Incorrect fuses on Power Distribution Module (PDM) on Standard Rear Discharge Mixer

Date: January 12, 2023
Bulletin Name: MXR-TSB-031
Model: Standard Rear Discharge Mixer
Model Year: 2022

Figure 6

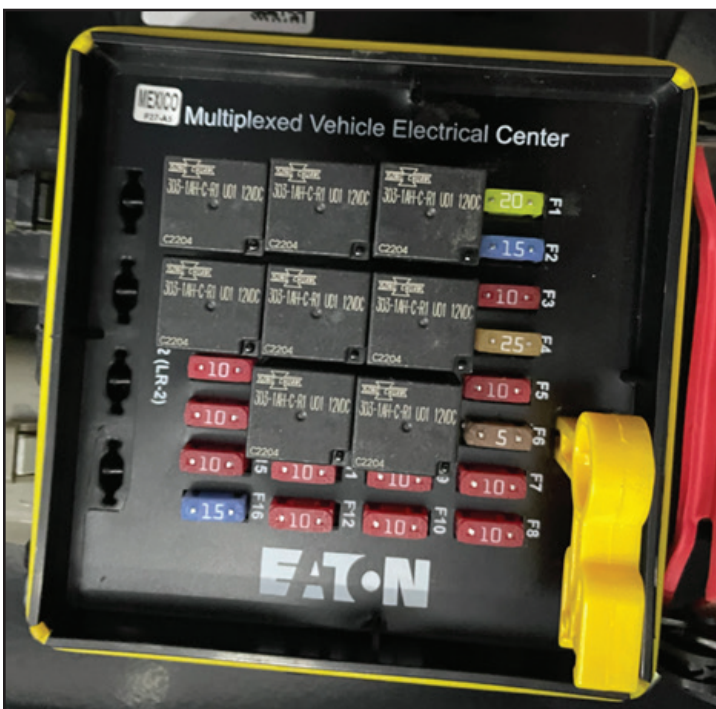
5. Using the fuse removal tool, replace fuses F1, F2, F4, F6, and F16 with the fuse amperage listed below:

- F1 fuse needs to be 20A (PN 1241726)
- F2 fuse needs to be 15A (PN 1241725)
- F4 fuse needs to be 25A (PN 1241727)
- F6 fuse needs to be 5A (PN 1241722)
- F16 fuse needs to be 15A (PN 1241725)
